Town of Medway
DESIGN REVIEW COMMITTEE
155 Village Street
Medway MA 02053
508-533-3291
drc@townofmedway.org

Update - July 11, 2019

TO: Medway Zoning Board of Appeals
FROM: Matthew Buckley, Chairman
RE: DRC Comments – 39 Main Street 40B development

Main Street Medway | Option 2

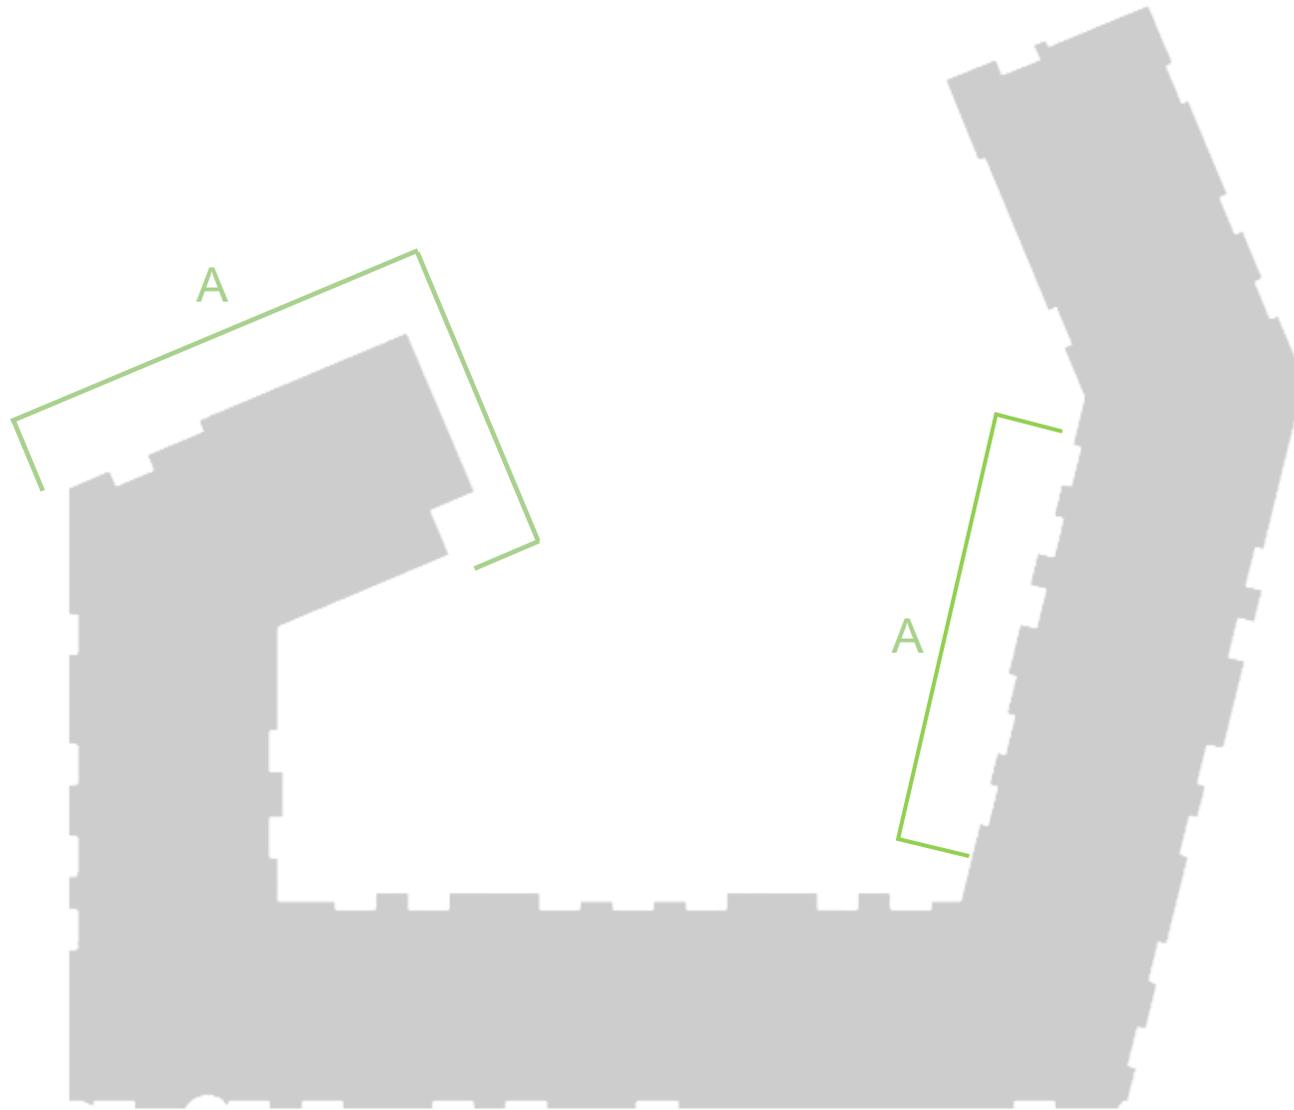
The attached document prepared by Cube 3 show renderings of the “C” shaped building that incorporate a more articulated architectural form as described in our previous letter. These drawing have been updated to include some additional details, such as stone cladding along portions of the base of the building. The DRC had requested that Cube 3 explore the application of these designs to different portions of the structure to most effectively break up the size and length of the building. This has been done and the DRC recommends Option 2.

The DRC believes this provides the most amount of visual break-up to the large building without creating a repetitive rhythm. The accompanying diagram illustrates the locations along the “C” shaped building that the various details will be incorporated. In Option 2, the Mansard roofline and associated trim is incorporated at the West end of the building and a section mid-way along the eastern portion of the building. The West end of the building, closest to the entryway, includes the most fully developed design. The Eastern section provides a hybrid of that on the West end, with its end portion featuring the stone cladding alone and the adjacent portion with mansard and associated trim but no stone cladding.
